2024/0112

Erection of 1no. dwelling.

Land to the South of 52 Tower Street, Worsbrough Common, Barnsley, S70 1QS

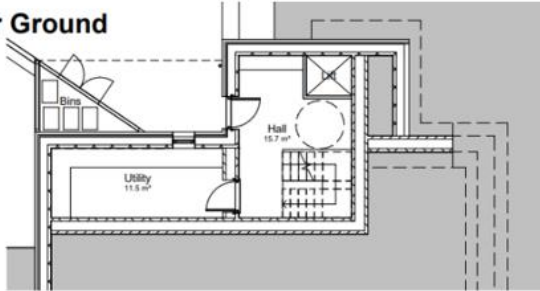
The proposed garden would be to the south but wrap around the eastern elevation. Landscaping would be added along the western slope of the site. The submitted site plan (Rev: E) suggests that the majority of the trees in the north-west corner would need to be removed to facilitate the proposed access/driveway.

The application site boundary includes a sliver of land to the west of the site, which overlaps the application site/proposed highway improvements associated with the approved bungalow opposite. The submitted site plan annotates this as '*land left free to facilitate future adopted highway 2020/0684*'.

The site plan does not include details of proposed boundary treatments to enclose the residential plot.

Ground Floor
1 : 100

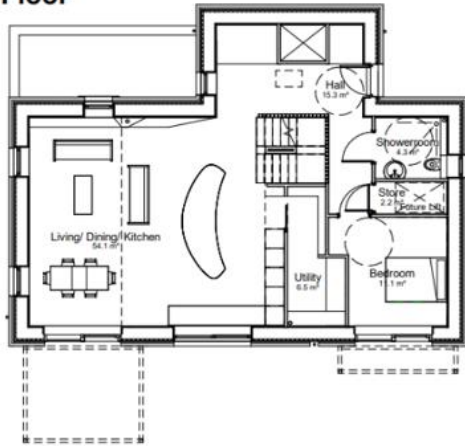
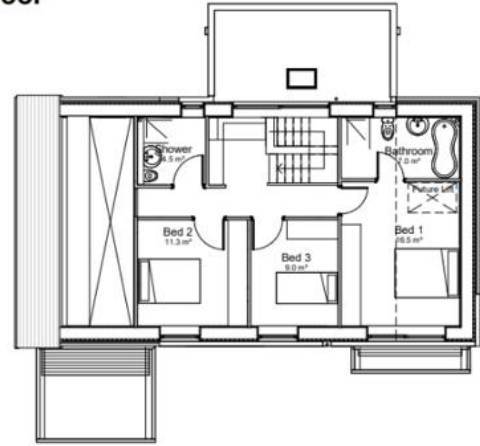
The dwelling would be centrally positioned within the plot, though sited perpendicular the street. The proposed dwelling is arranged over 2-3 storeys with the main living accommodation and one bedroom at ground floor level and 3 further bedrooms at first floor level. A utility and entrance hallway are proposed at the lower ground floor level accessed via the driveway.
